Access Compliance Report

Public Rights-of-Way (Curb Ramps)

Intersection ID: 7448	Main Street: ROCKY_RIVER_RD	Cross Street: GRIER_RD	Location: NW
ADA ID: 0CC76DB84B78	Ramp Type: Para	Initial Pass/Fail: Fail	Overall Compliance: No
		Severity Score: 12.5

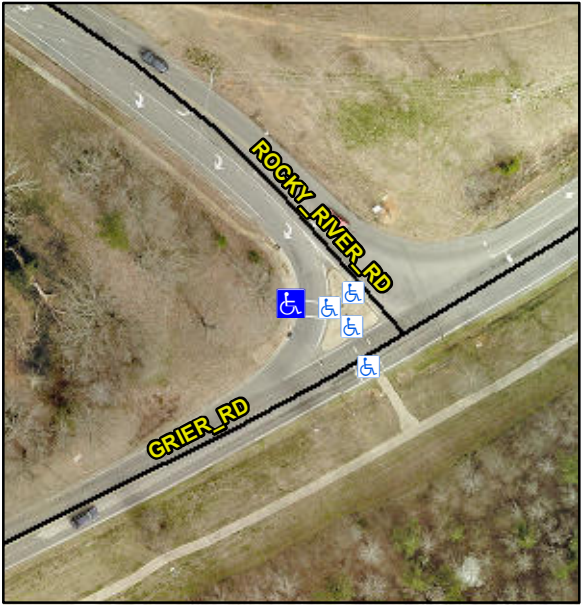
Codes/Mitigation Info/Possible Solution			Field Measurements/Component Compliance		
	Possible Solutions:		Compliance	Description	Data
	Remove & Replace Entire Ramp.		Compliance	Description	Data
			N/A	Ramp Length LT (in)	70.0
			Yes	Ramp Width LT (in)	70.0
			Yes	Ramp Slope LT (%)	3.5
			No	Ramp XSlope LT (%)	6.2
			N/A	Landing Length (in)	N/A
			N/A	Landing Width (in)	N/A
			N/A	Landing Slope (%)	N/A
			N/A	Landing X Slope (%)	N/A
<p>Surveyor Notes:</p> <p>LT & RT RP SL < 5%, DAMAGED DWS</p> <p>PROW/ADA:</p> <p>Not Found, R304.5.3</p>			N/A	Ramp Length RT (in)	57.0
			Yes	Ramp Width RT (in)	64.0
			Yes	Ramp Slope RT (%)	4.2
			No	Ramp XSlope RT (%)	5.6
			N/A	DWS Provided?	N/A
			N/A	DWS Contrast?	N/A
			N/A	DWS Length (in)	N/A
			N/A	DWS Full Width?	N/A
			N/A	DWS Offset (in)	N/A
			N/A	Shared Landing?	N/A
			N/A	Gutter Ponding?	N/A
			N/A	Gutter Lip Ht (in)	N/A
			N/A	Painted X Walk1?	Yes
				X Walk 1 Direction	To E

N/A	X Walk 1 Width (in)	85.5
				X Walk 1 Slope (%)	0.3
				X Walk 1 X Slope (%)	0.9
			N/A	Ramp inside XWalk1?	Yes
			N/A	Road Slope (%)	N/A
			N/A	Road X Slope (%)	N/A
			N/A	Any Obstructions?	N/A
				Obstruction Type	
<p>Total Cost:</p> <p>\$ 1600.00</p>			N/A		N/A
			Yes	Surface Condition? (G/P)	Good
			Replace	Curb Slope (%)	16.5
